Groundwater Application Review Summary Form

Application # G- 18800

To: Kristopher Byrd, Well Construction and Compliance Section Manager
From: Joel Jeffery, Well Construction Program Coordinator
Subject: Review of Water Right Application G-18800
Date: July 1, 2019

TO: Water Rights Section Date 6/19/2019
 FROM: Groundwater Section Travis Brown
 Reviewer's Name
 SUBJECT: Application G- 18800 Supersedes review of _____
 Date of Review(s) _____

Hydrographs – Annual Precipitation and Annual Spring Water Levels for Obs Wells > 250 ft bls

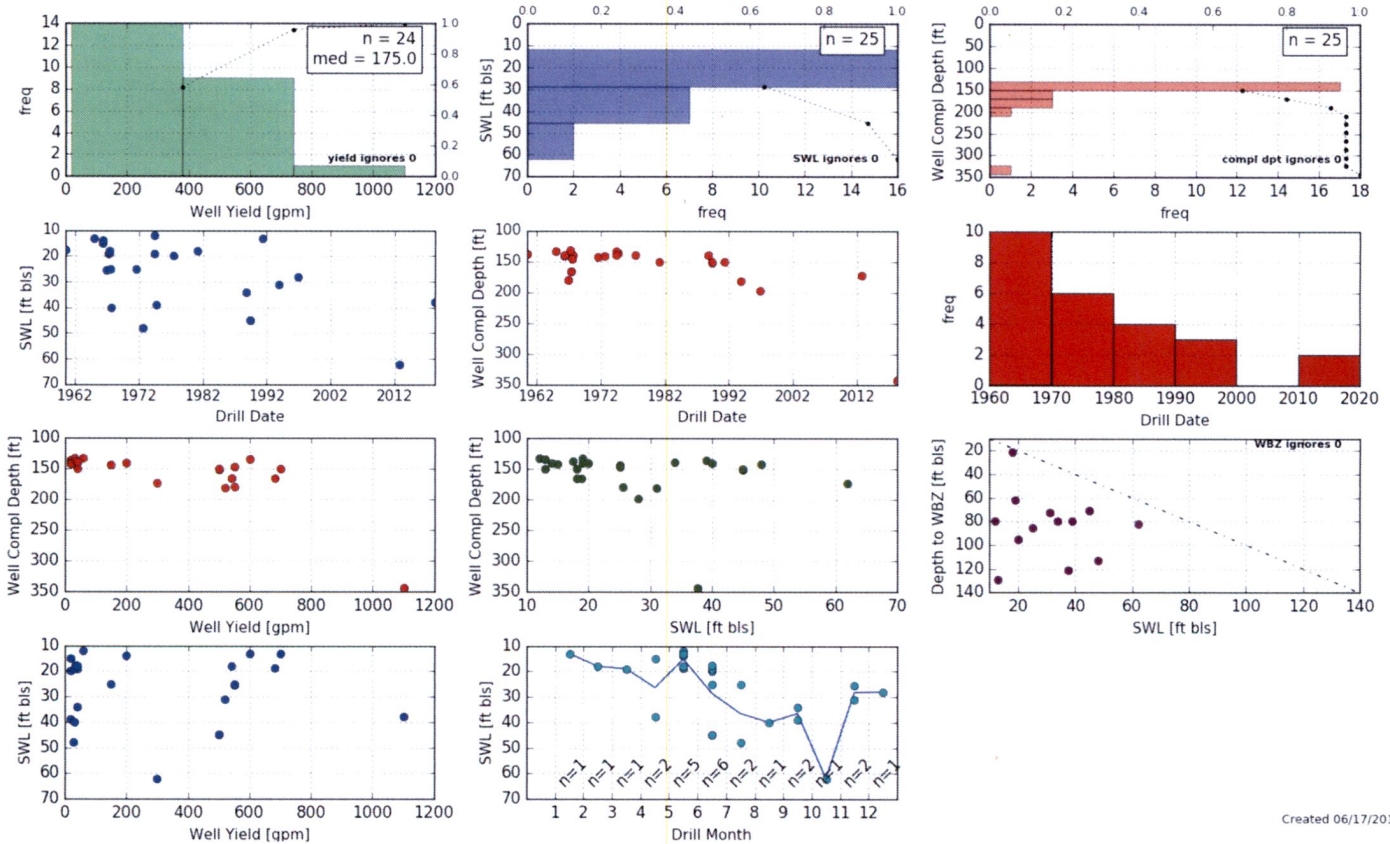
Permit G-17865 authorizes the applicant to divert up to 1.29 cfs (~579 gpm) from MARI 67957. This application requests an additional 0.42 cfs (~188 gpm) from MARI 67957 (POA 1), which would result in a total pumping rate of up to 1.71 cfs (~767 gpm) from MARI 67957. The yield reported for MARI 67957 on its water well report is 1,100 gpm (~2.45 cfs) so the well would appear to be capable of diverting the requested amount. Reported static water levels for wells completed to similar depths as MARI 67957 do not indicate persistent or widespread declines in the alluvial aquifer (see attached Hydrograph).

Theis Drawdown at MARI 18033

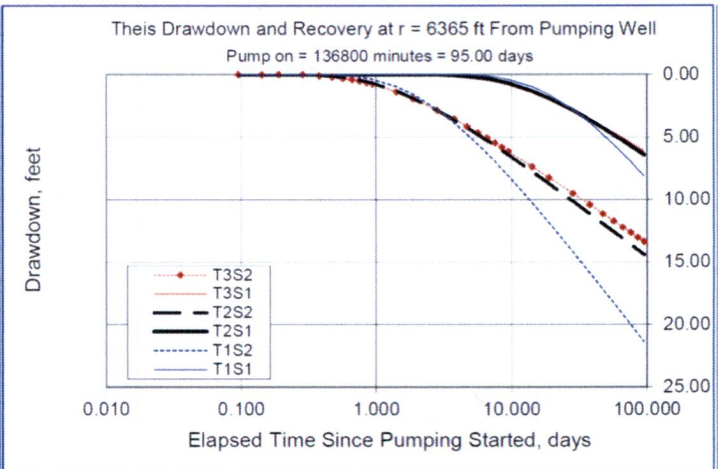
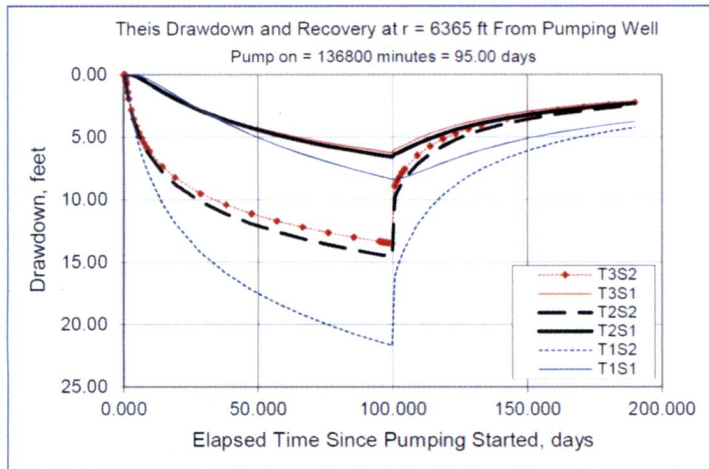
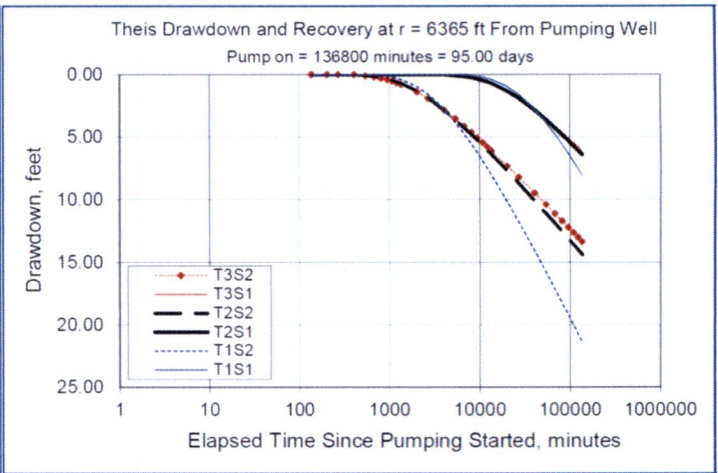
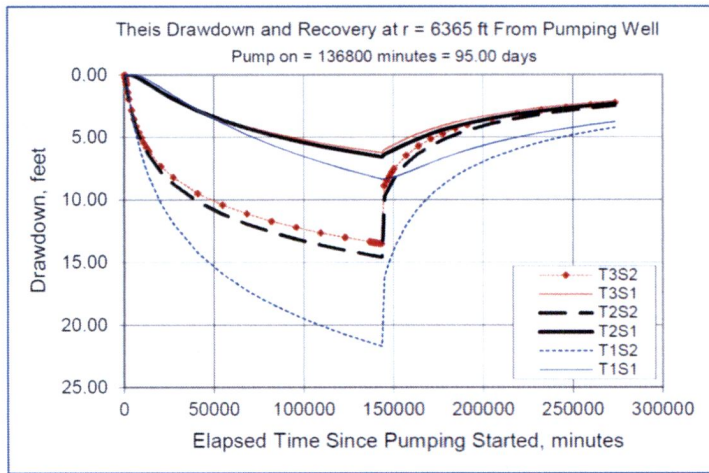
The nearest known water supply well completed in a water-bearing zone (WBZ) similar to POA 1 (MARI 67957) is MARI 18033, authorized POA for Certificate 89753 and Permit G-11852, ~6,365 ft north of POA 1 (MARI 67957). Theis (1935) drawdown analysis of potential well-to-well interference with MARI 18033 does not indicate that the proposed use would deprive the users of MARI 18033 of their customary use of groundwater (see Theis Drawdown at MARI 18033, attached).

- Total pumping time represents time to reach combined maximum annual volume (321.25 af) at combined rate of 767 gpm (1.71 cfs).
- Transmissivity values represent 25th, 50th (median), and 75th percentile values from analyzed pumping tests.
- Storativity representative of sand and gravel aquifer (Domenico and Mifflin, 1965).

Stream Depletion Analysis – SW 1

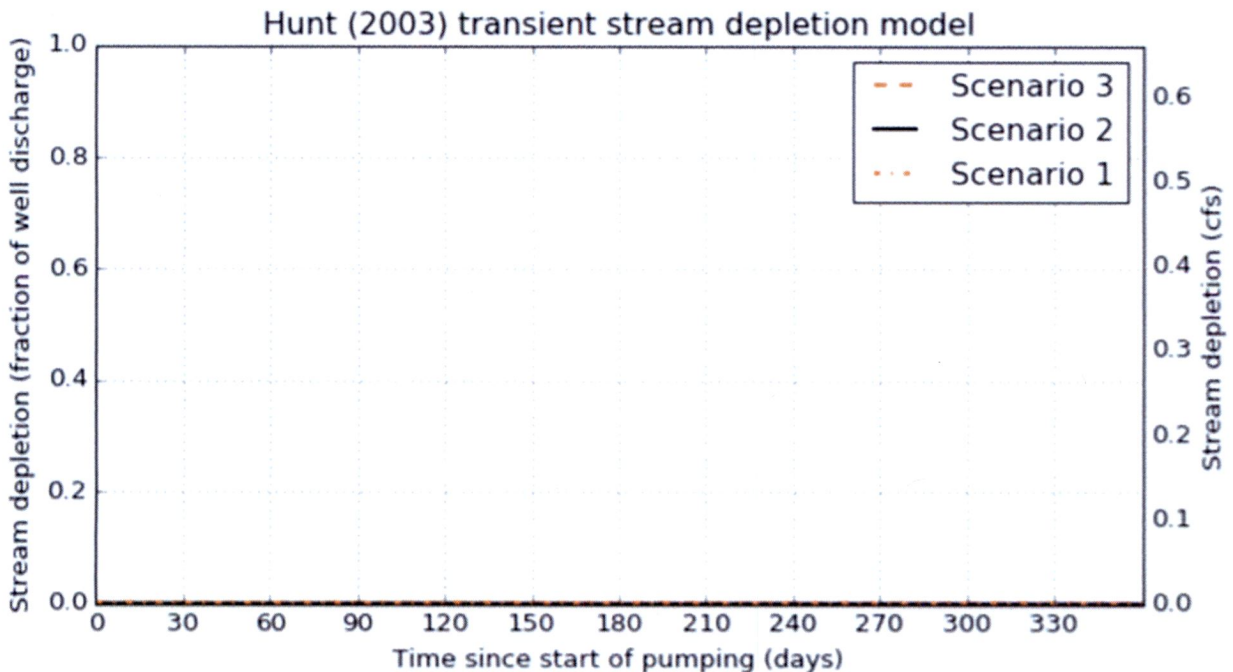
The Hunt (2003) model results indicate that depletion of SW 2 is expected to be negligible one year after the proposed use begins. The thick deposits of low-permeability Willamette Silt overlying the Willamette Aquifer in this area and the relatively great distance from the POA to hydraulically-connected surface water provide an effective buffer from stream depletion effects within the period of evaluation.
